**CHAPTER 11**  
**REQUEST FOR WAIVER FROM ACCESSIBILITY REQUIREMENTS**  
**CHAPTER 553, PART V, FLORIDA STATUTES**  
**August 1999**

MODIFICATION PER  
ADA CODE REQUIREMENTS  
CHANGE OF USE

**SLIP N' SLIDE RECORDS**  
919 4TH STREET  
MIAMI BEACH, FL 33139

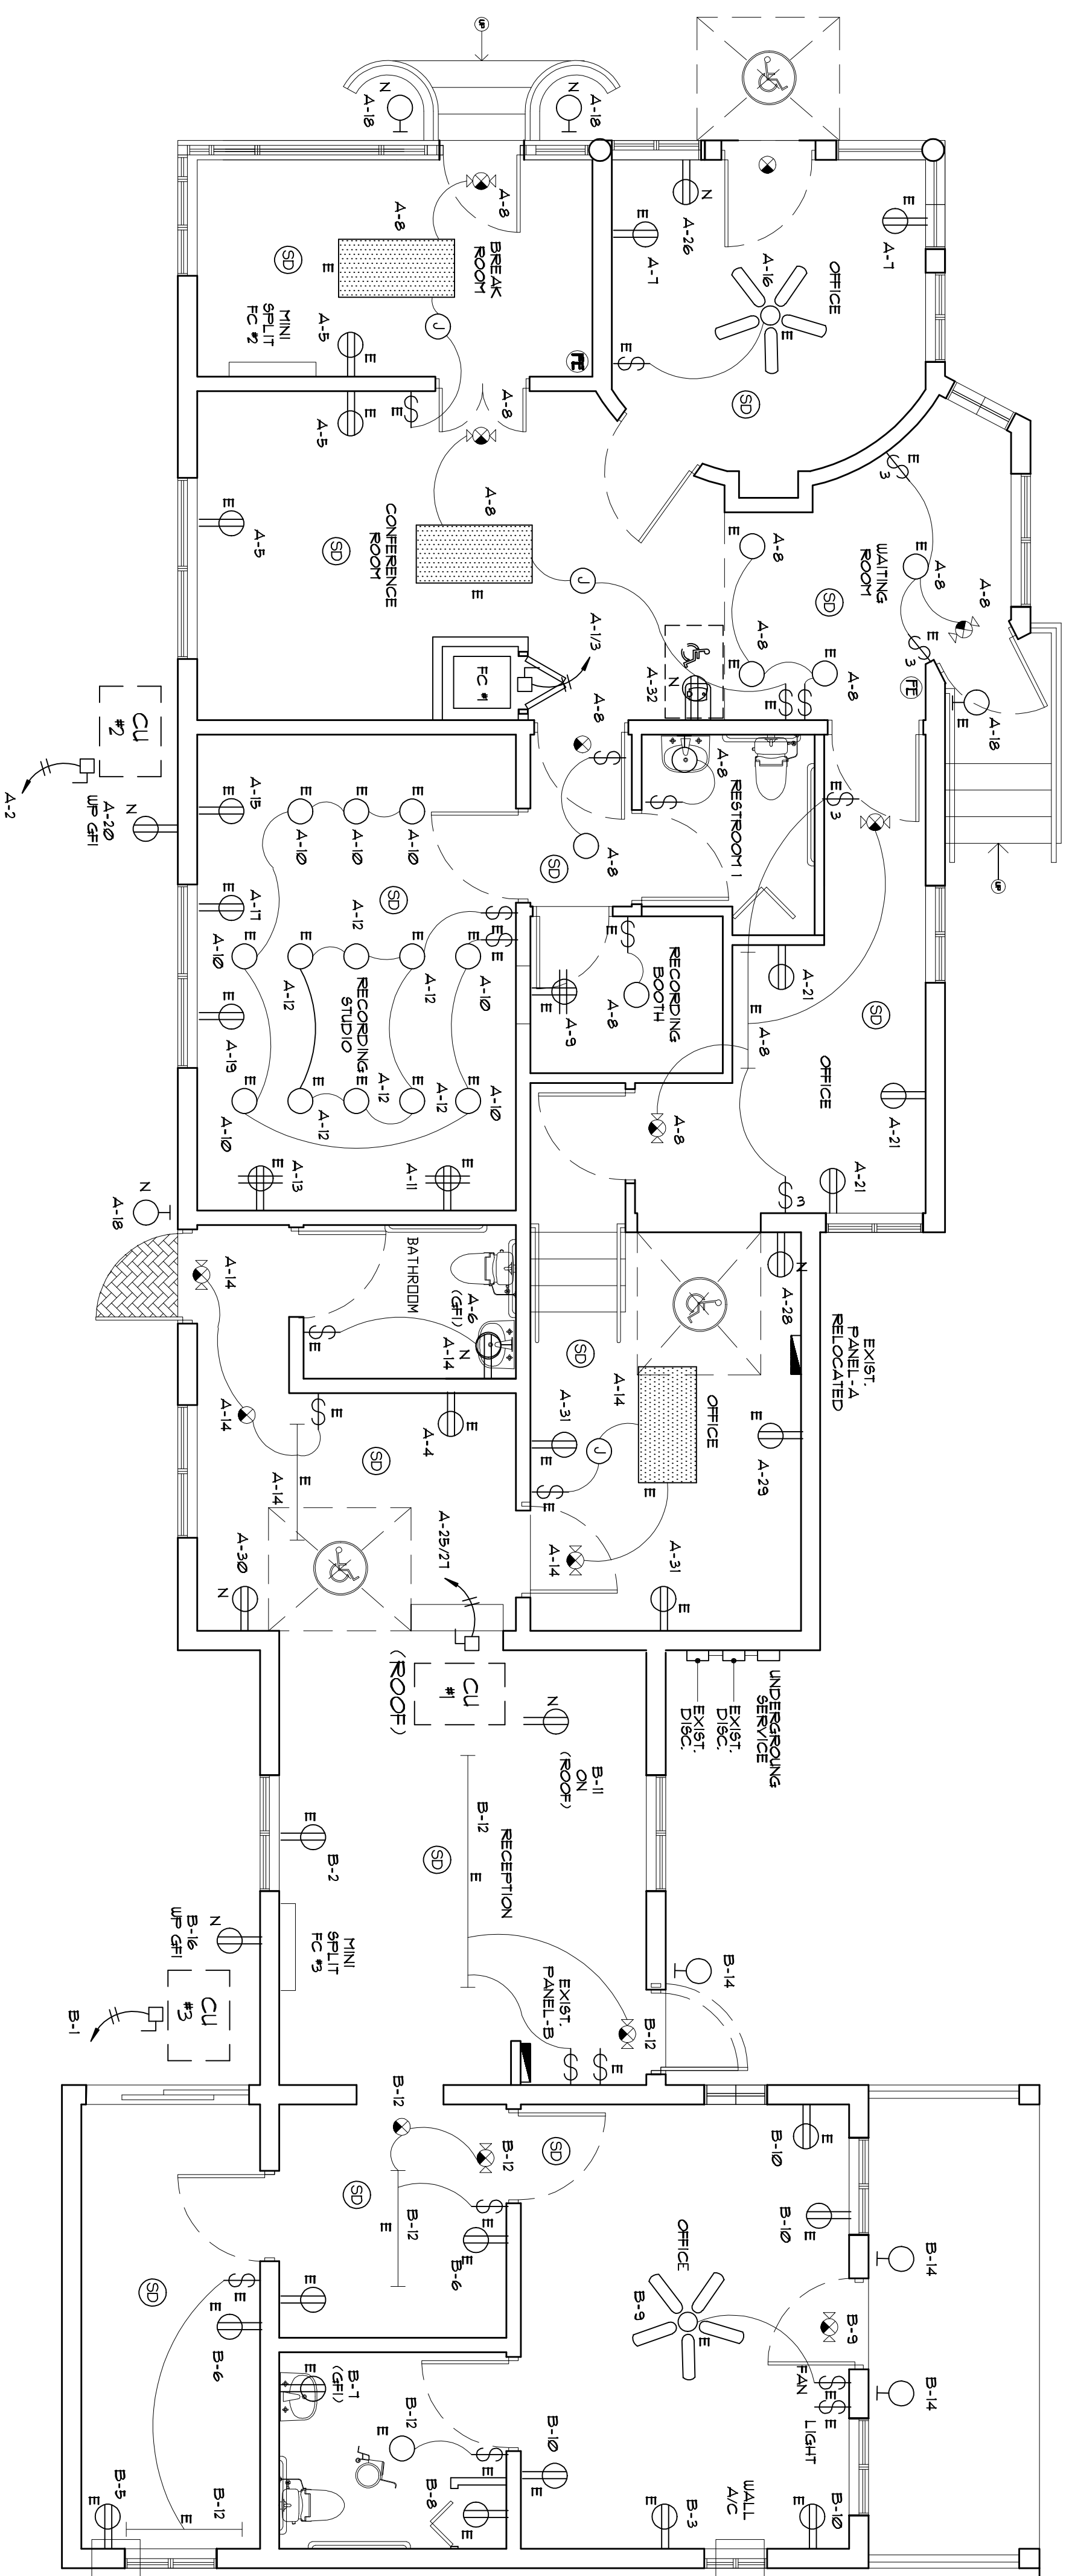
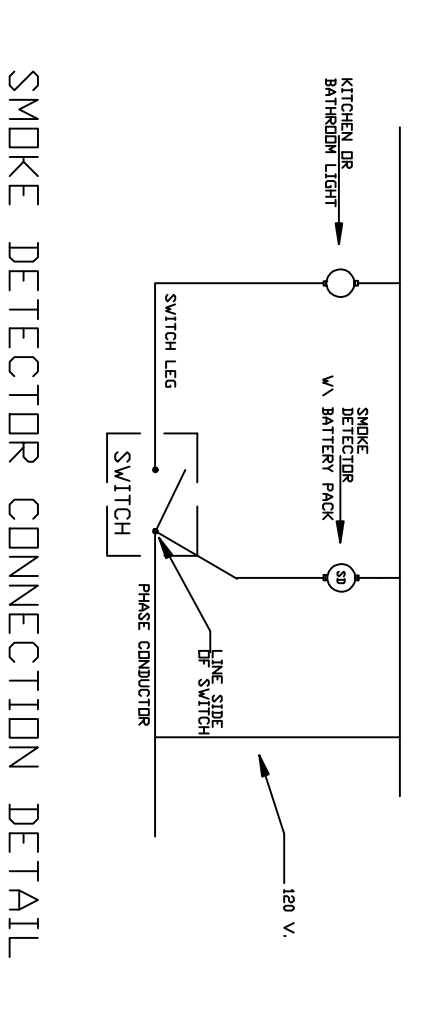
sheet e-1:

1. provide info on sd's, are they single station? if yes, state on plans that all shall be 120v/w battery backup and located min 36" from any a/c grille

sheet e-1:

1. provide info on sd's, are they single station? if yes, state on plans that all shall be 120v/w battery backup and located min 36" from any a/c grille (NOTE HAS BEEN ADDED BUT THE SD'S ARE NOT SHOWN)

DRAWING No. 10-2504 A-1  
SHEET P-1

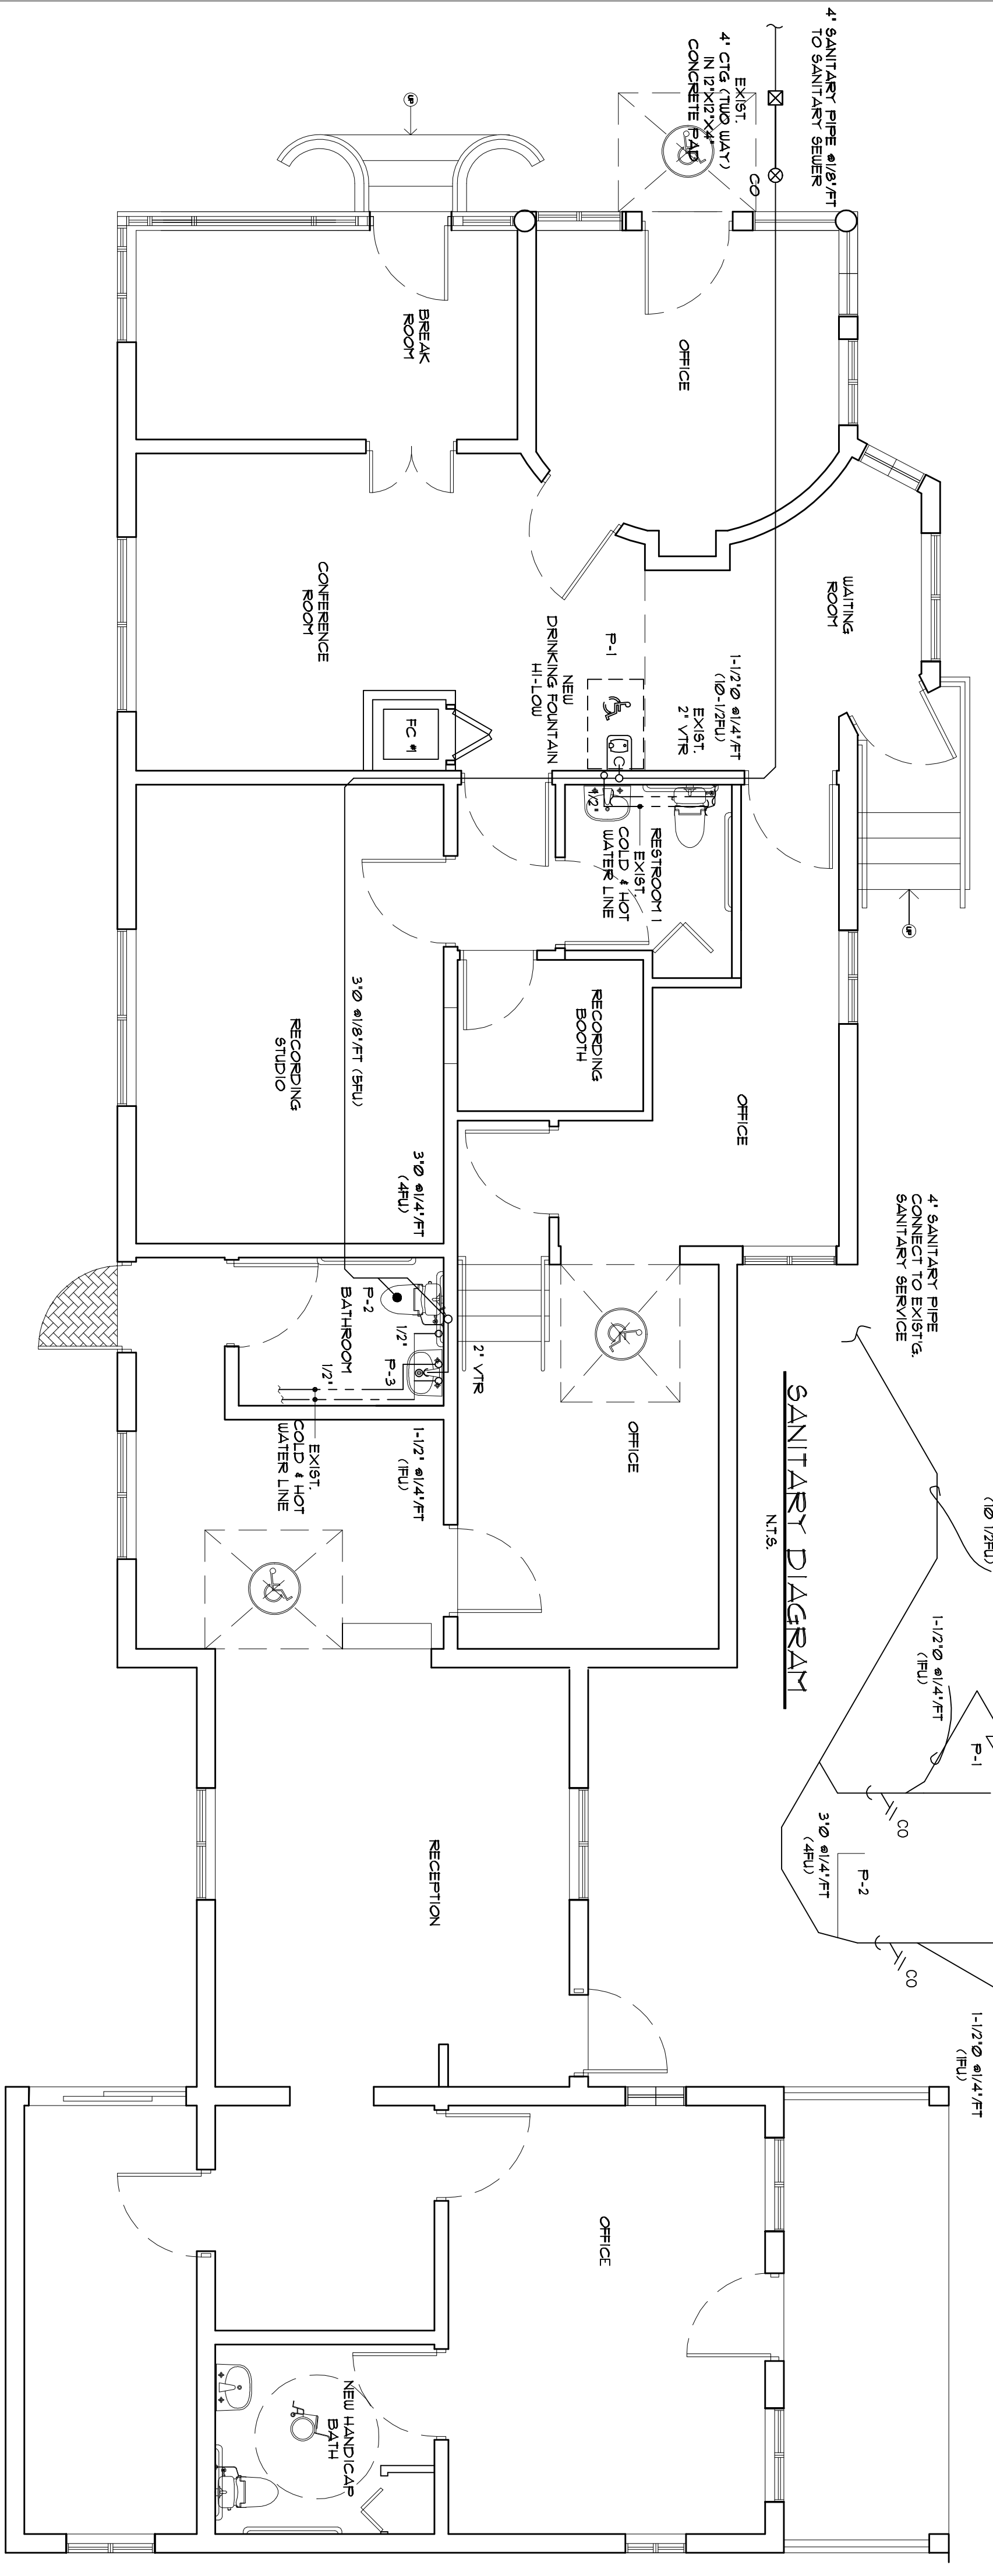
-F-1 -Provide fixture and faucet compliance with max. water consumption rates as per Miami Dade ord. 08-14.

-F-1 -Provide fixture compliance with referenced standards as per FBC Plb 406 through 421.

-F-1 -Correct fixture and faucet to comply with max. water consumption rates as per Miami Dade ord. 08-14.
